Access Compliance Report Public Rights-of-Way (RR Crossings)

Intersection ID: 53713	Main Street: N_TRYON_ST	Location: N/A
ADA ID: C226A87C326D	Overall Compliance: No	Severity Score: 0.0
Codes/Mitigation Info/Possible Solution		Field Measurements/Component Compliance

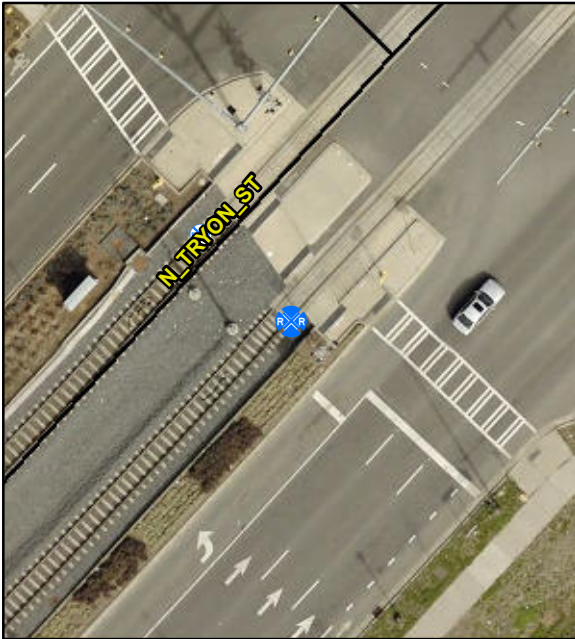
**Remove & Replace Detectable
Warning System. Provide Pedestrian
Gate. Remove & Replace Walking
Surface Adjacent to Rail.**

R302.7.4, R305.2.5
